NUMBER: 08-003-21

This bulletin supersedes Technical Service Bulletin 08-074-20 REV. F, date of issue December 03, 2020, which should be removed from your files. All revisions are highlighted with **asterisks**** includes additional notes.**

Improved Steering Feel

2018 - 2020	(JL)	Jeep Wrangler
2020	(JT)	Jeep Gladiator

Fig. 1

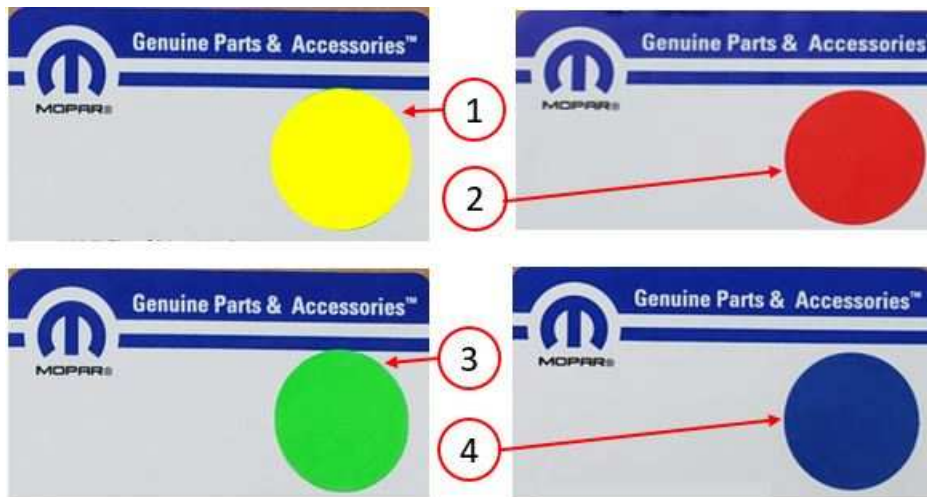
The Steering Gear Parts Label Has A Color Dot On It To Help Confirm The Correct Steering Gear Was Ordered

- 1 - Yellow Dot, 68507576AA (JT Left Hand Drive (LHD))
- 2 - Red Dot, 68507569AA (JL 4 Door LHD, **W/O EXJ 3.0 Diesel**)
- 3 - Green Dot, 68507574AA (JL 4 Door LHD, **With EXJ 3.0 Diesel**)
- 4 - Blue Dot, 68507571AA (JL 2 Door LHD)
